Parkhill

PROJECT NO.: 03.9006.20 1/11/2022 DATE: January 11, 2022	ADDENDUM NO: 004	Permian Basin (and Economic I Building - Midla	ALL PLANHOLDERS Parkhill E: University of Texas UTPB) Center for Energy Diversification (CEED) nd Campus & Dunagan s Building on the Odessa B	Contraction of the second seco
DATE: January 11, 2022		PROJECT NO.:	03.9006.20	1/11/2022
		DATE:	January 11, 2022

This Addendum consists of 2 pages and the attachments: Project Manual: Section 00 42 00 Proposal Form, Section 01 23 00 Alternates. CEED Building Drawings: Sheet A-111 – ANNOTATED/DIMENSIONAL FLOOR PLAN- AREA A, Sheet A-131 – REFLECTED CEILING PLAN – AREA A, Sheet A132– REFLECTED CEILING PLAN-AREA B, Sheet I-121 – WALL FINISH PLAN – AREA A Appendix: RFI Responses

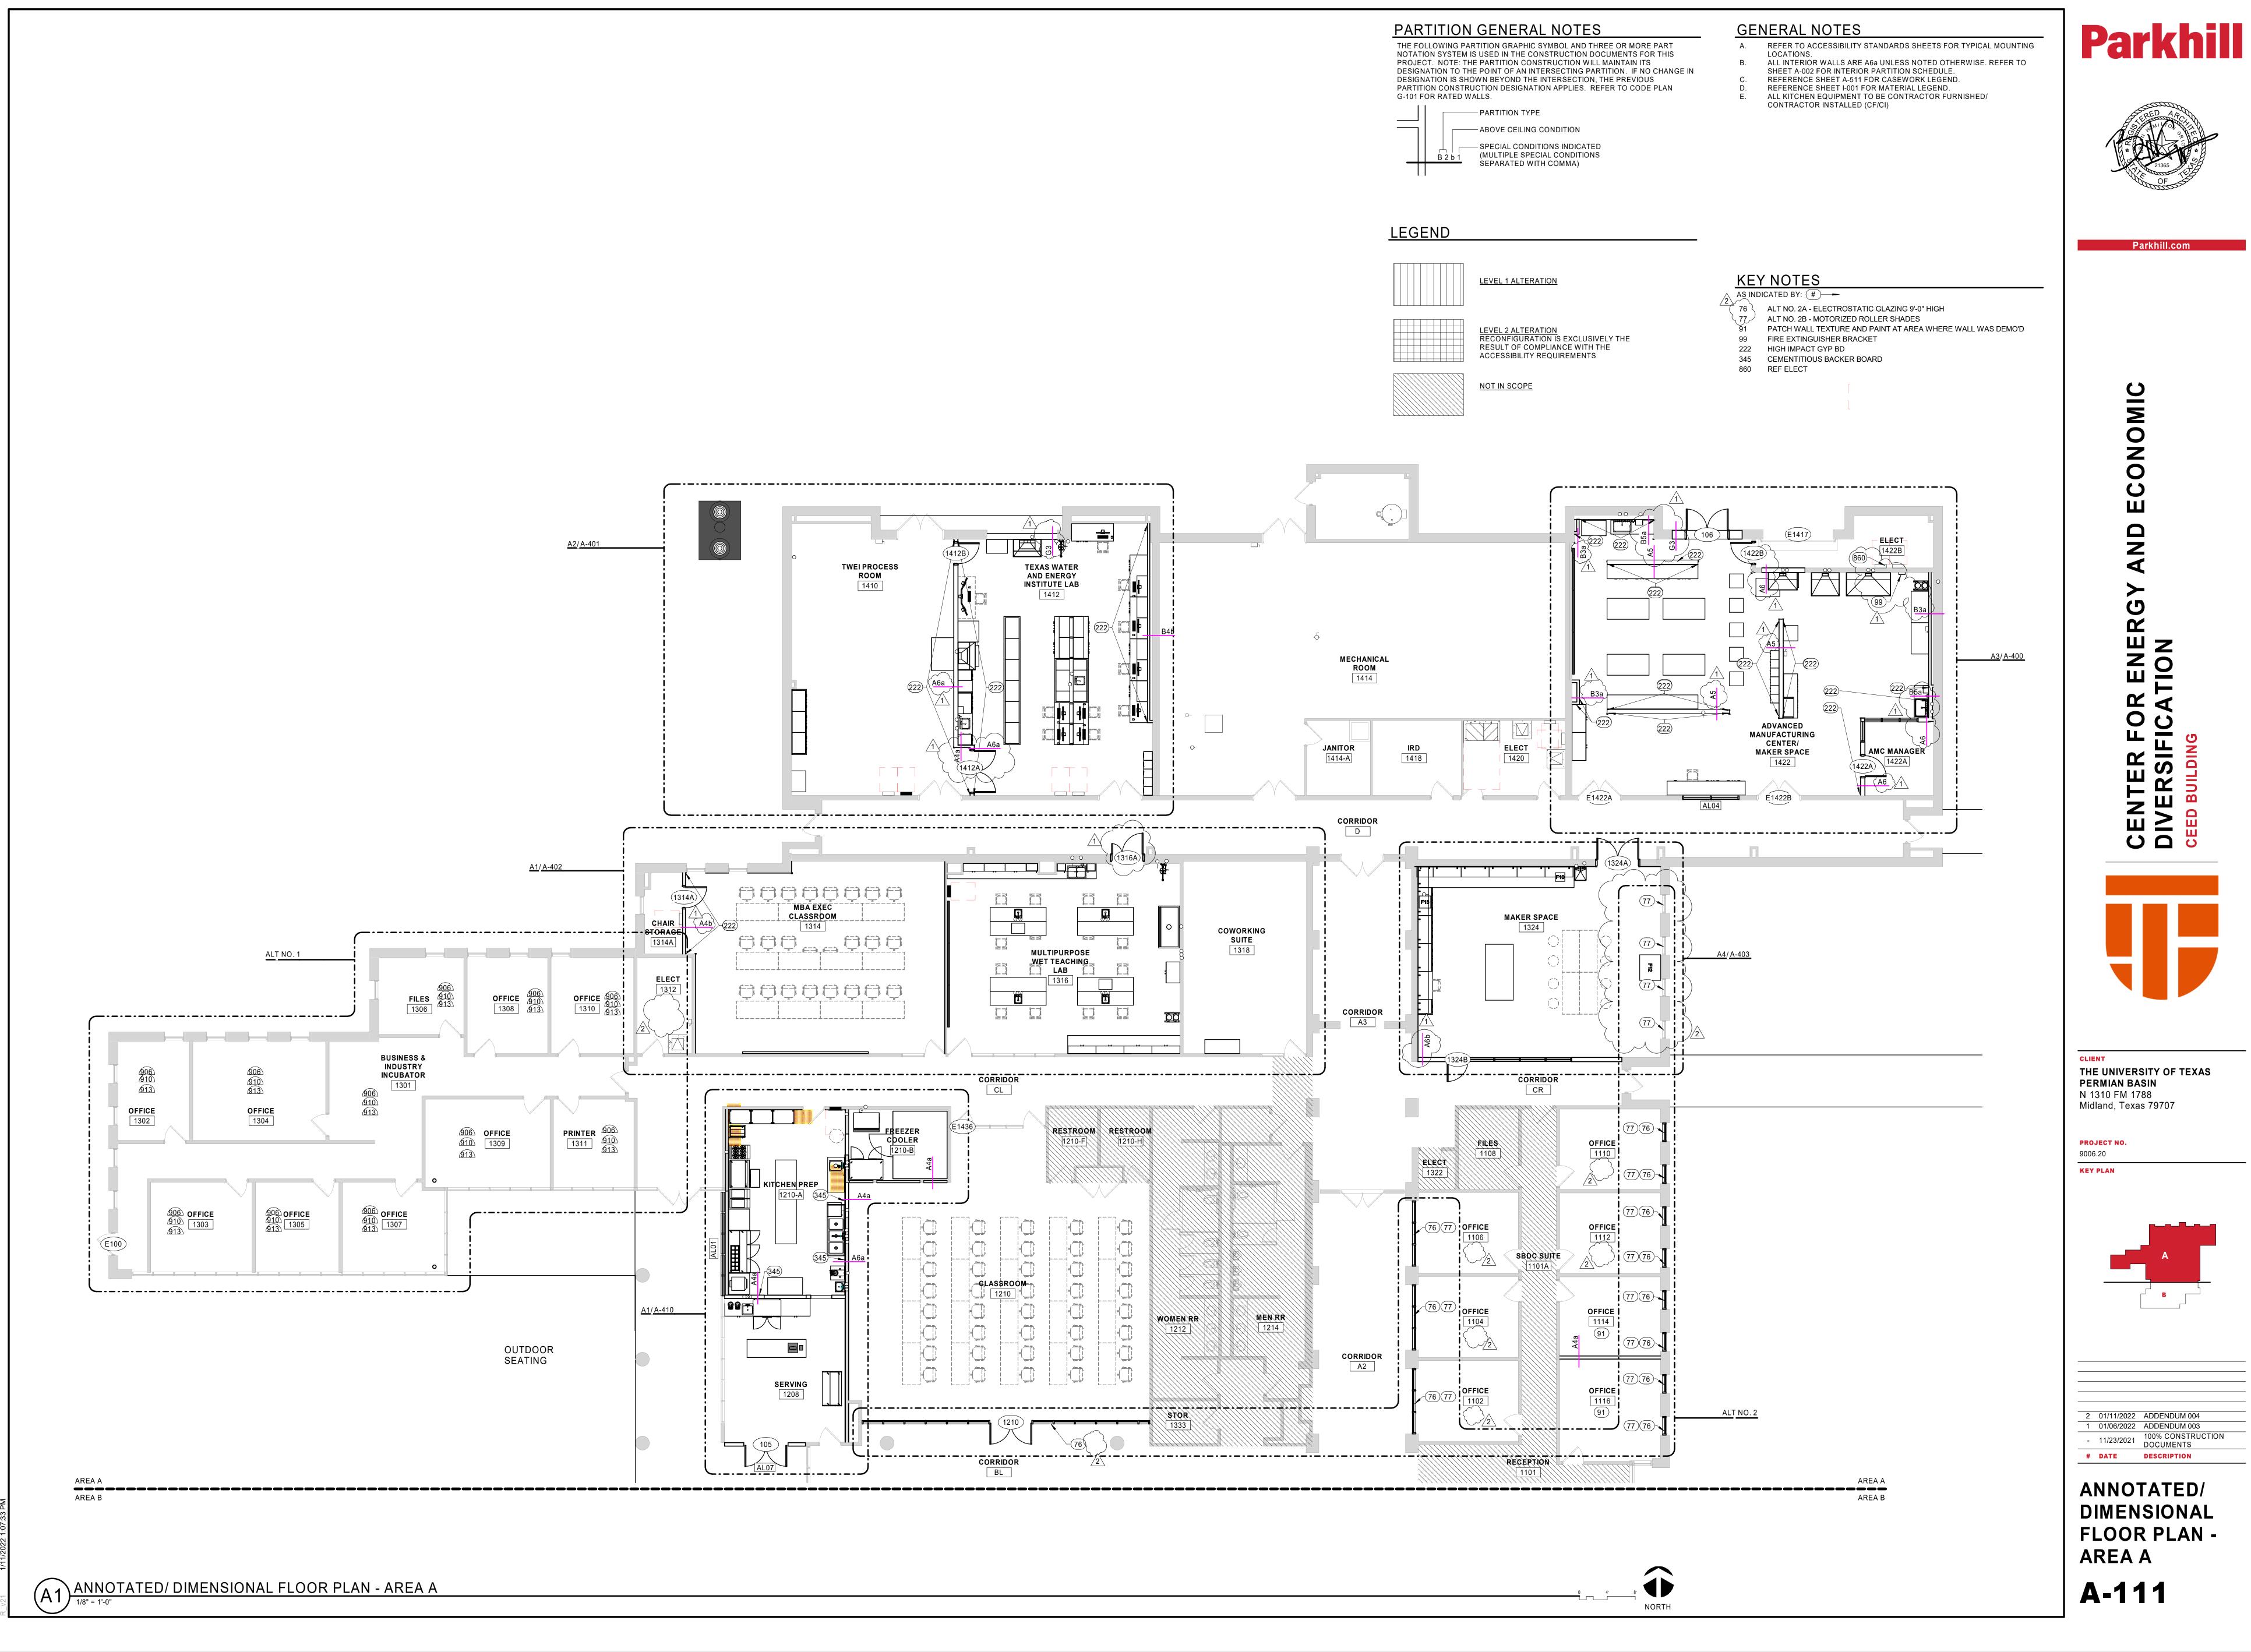
- SHEET A-111 ANNOTATED/DIMENSIONAL FLOOR PLAN- AREA A
 a. REMOVE and REPLACE Sheet A-111 in its entirety as attached in this Addendum
 - 1) Omit notes 906, 910, and 913 in Electrical Room 1312- there is no work in this room, it is to remain as is
 - 2) Clarify Alternate 2 locations updated and clarified
 - 3) Revised keynotes 76 and 77

81)Request: Reference Sheet A-111 Key note 77 references a deduct alternate 2 for roller shades. This doesn't match the alternate descriptions.

Response: Refer to Addendum #4 for changes to keynotes

- SHEET A131 REFLECTED CEILING PLAN AREA A

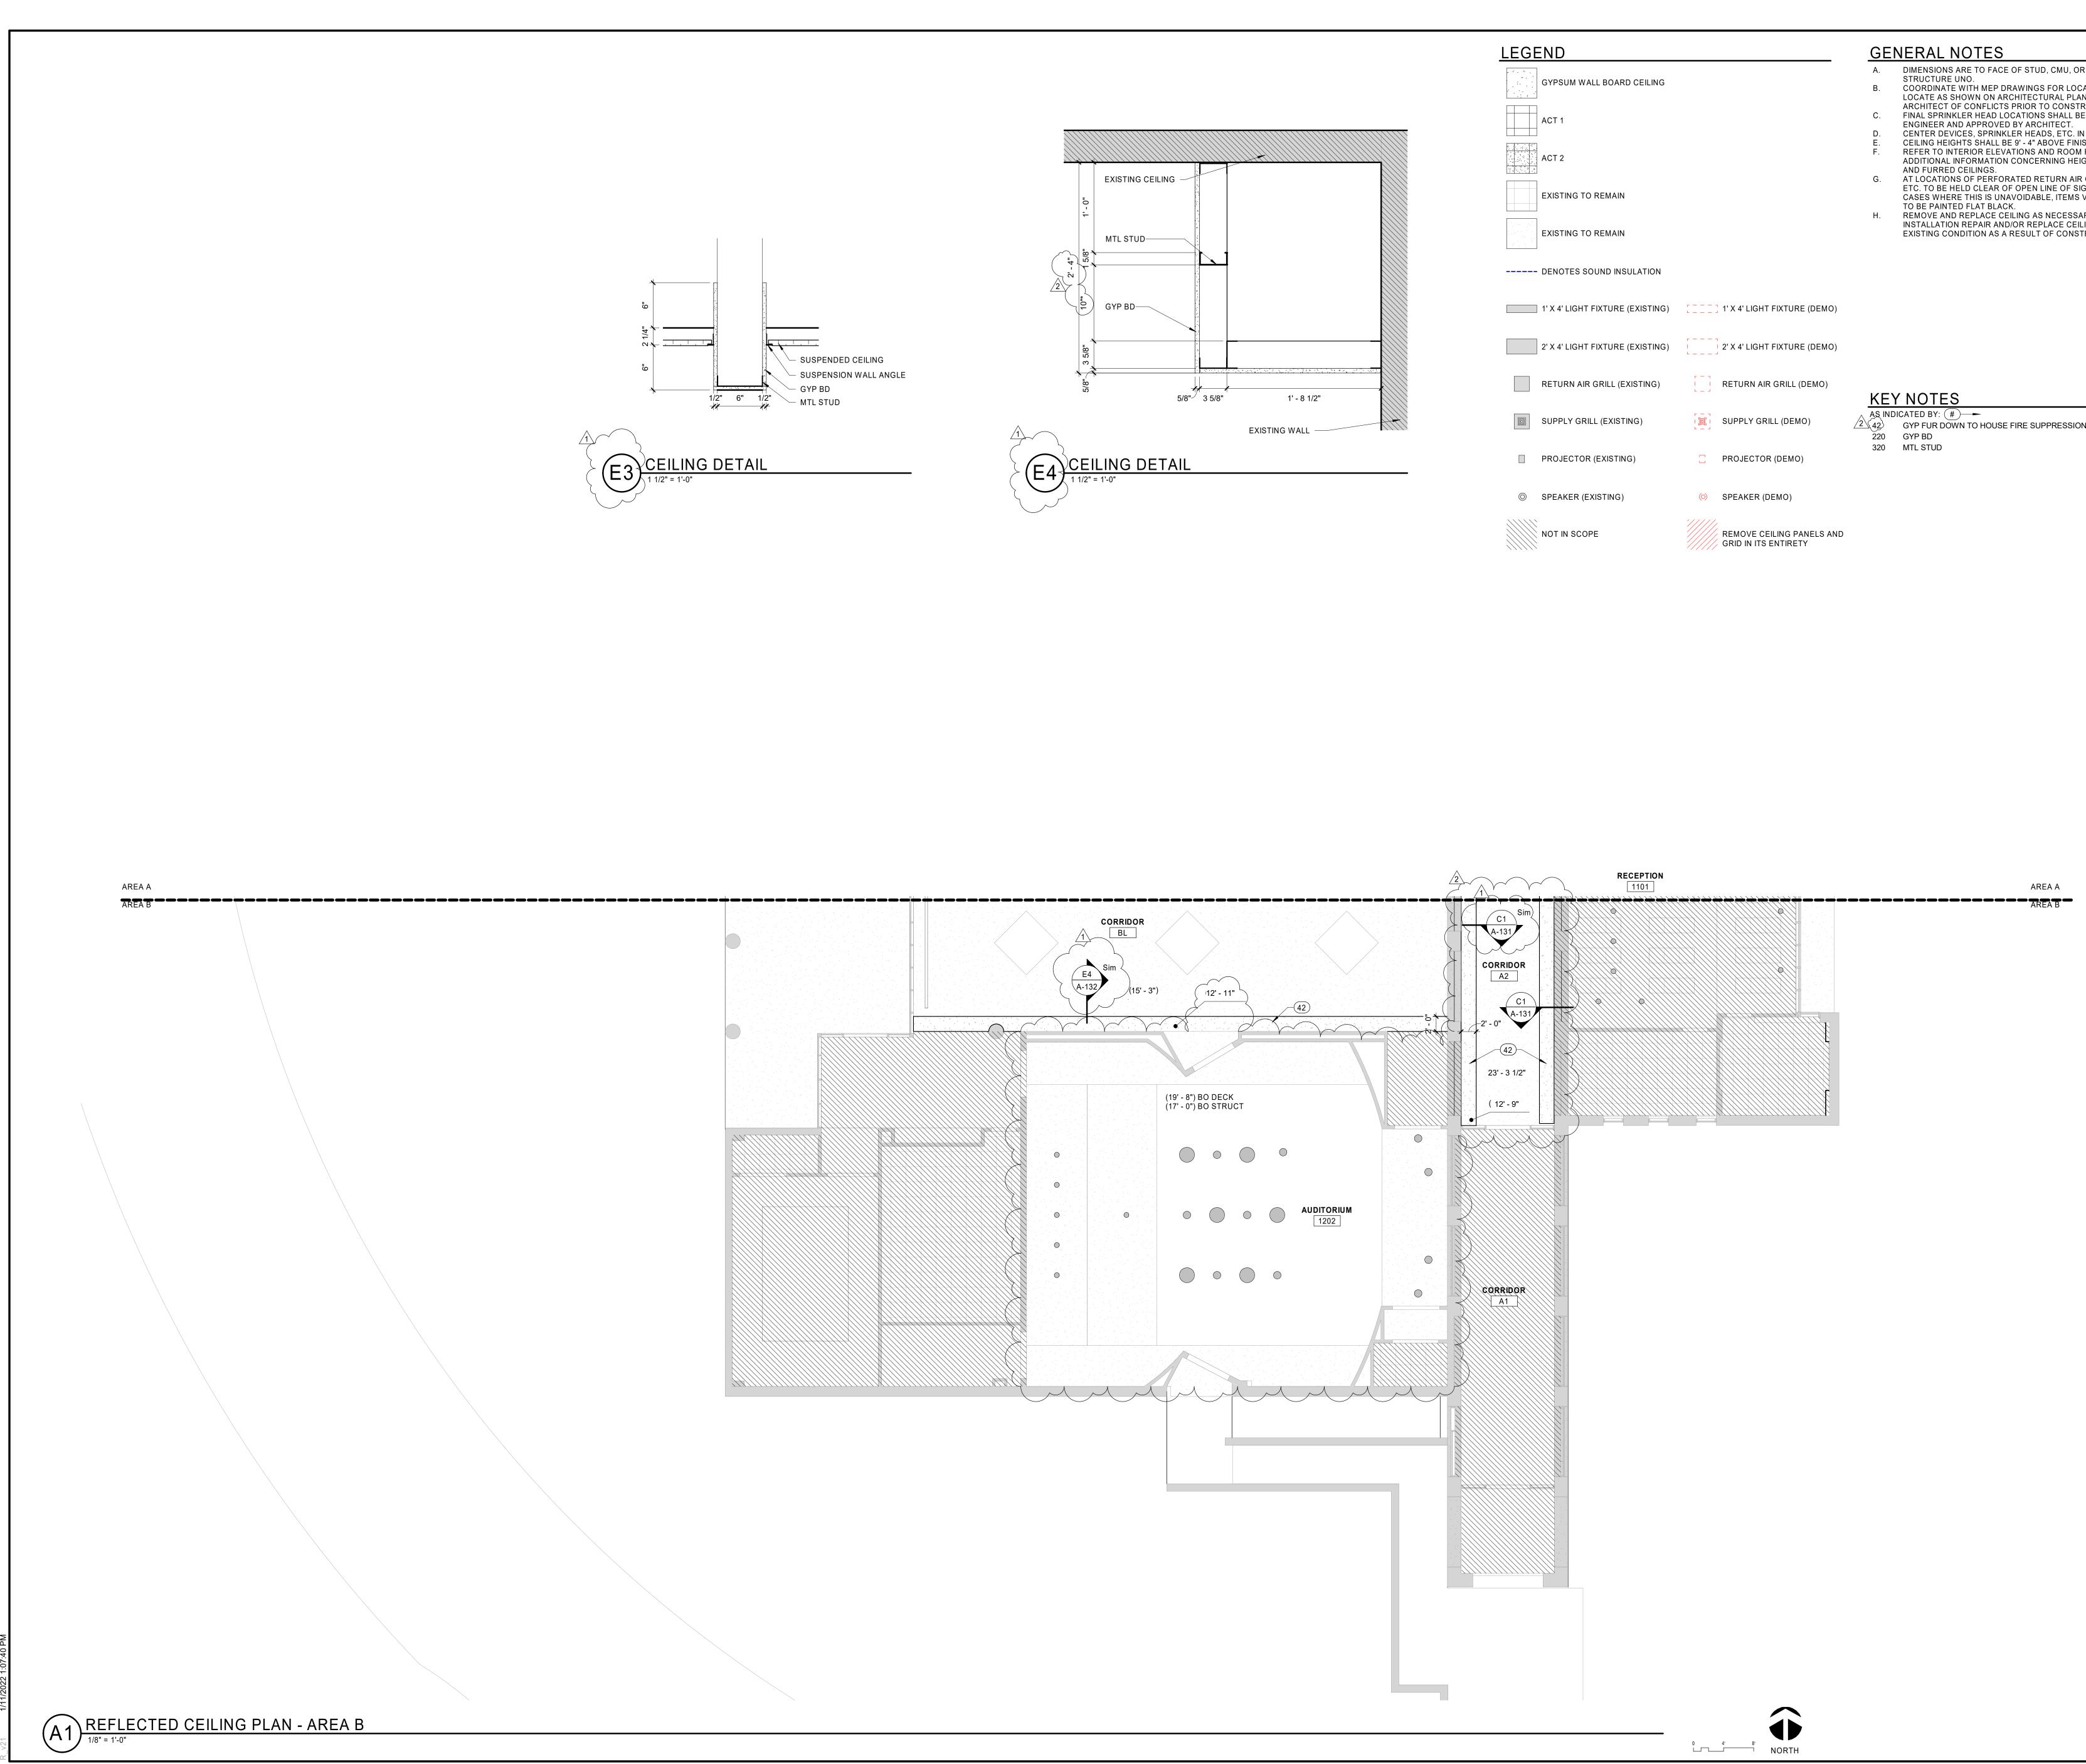
a. REMOVE and REPLACE Sheet A-131 in its entirety as attached in this Addendum
 - 1) Added Detail C1
 - 2) Added Addendum 1 area call out
 - 3) Adjusted section to match area selected
 - 4) Adjusted furring ceiling height
 - 5) Revised keynote 42
- 6. SHEET A132– REFLECTED CEILING PLAN- AREA B

36) Request: Page A-131 of the CEED drawings note 42 references a detail D4 on page A-521. Will there be a detail for that section?

37) Request: Also- during our walkthrough meeting I took pictures of corridor A2 and it looks like there are windows at the top of the corridor where the fur down is showing. Will we be covering the windows in the corridor on the east wall?

Response: Yes, there will be a detail included in Addendum #4

Response: No they will not be covered up the furrdown in these locations will only go 3' high, the new detail provided in Addendum #4 will address this condition.
